MEMORANDUM FOR: Robert C. Jones, Chief  
Reactor Systems Branch  
Division of Systems Technology  
Office of Nuclear Reactor Regulation

FROM: Jack E. Rosenthal, Chief  
Reactor Operations Analysis Branch  
Division of Safety Programs  
Office for Analysis and Evaluation  
of Operational Data

SUBJECT: PROPOSED TECHNICAL SPECIFICATIONS AMENDMENT TO SECTIONS  
3/4.3.1, 3/4.4.2, 3/4.7.1, AND 3/4.7.2 FOR PALO VERDE  
NUCLEAR STATION, UNIT NOS. 1, 2, AND 3

## COMMENTS ON PROPOSED TECHNICAL SPECIFICATIONS CHANGES

**FIGURE 1: PALO VERDE PSV TEST RESULTS**

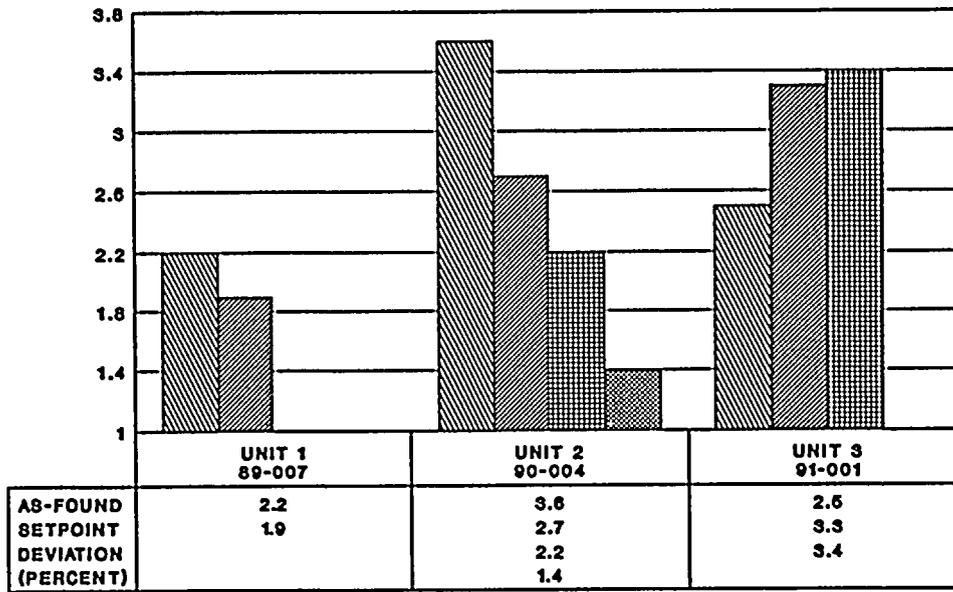
In Figure 1, "Palo Verde PSV Test Results," we see that the as-found setpoints for nine of the twelve PSVs tested were above the TS allowable tolerance. The remaining 3 were within  $\pm 1$  percent (okay). Figures 2a, 2b, 3a, 3b, 4a, and 4b show the as-found setpoint results for the MSSVs. Unit 1 MSSV setpoints are high for 19 valves, okay for 19, and low for 2. Unit 2 MSSV setpoints are high for 19, okay for 18, and low for 3. Unit 3 MSSV setpoints are high for 9, okay for 18 and low for 6. See Figure 5 for a graphic presentation of the variance distribution between as found and nominal setpoint. With a symmetric tolerance, one would expect to see as many valves low as high. Something is skewing the results. Something is causing the setpoint to "drift" high.

**FIGURE 6: AVERAGE SETPOINTS OF MSSVs AND RELATIONSHIP TO DESIGN PRESSURE**

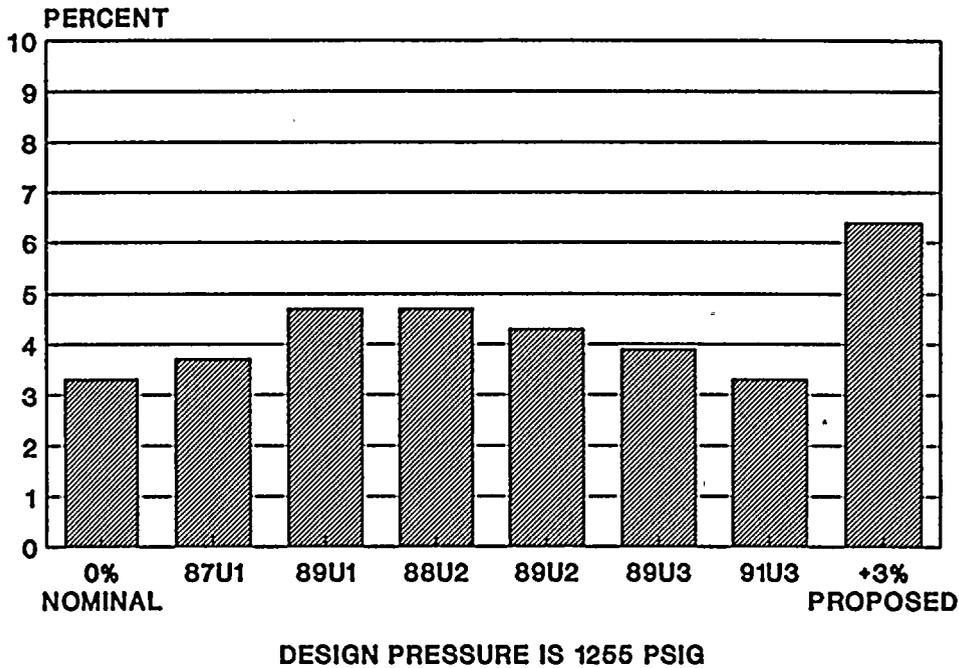
Figure 6: "Average Setpoints of MSSVs and Relationship to Design Pressure" shows the average variation from the setpoint of the valves tested. Except for the first group of valves tested for Unit 3, this is the average variation for all 20 valves.
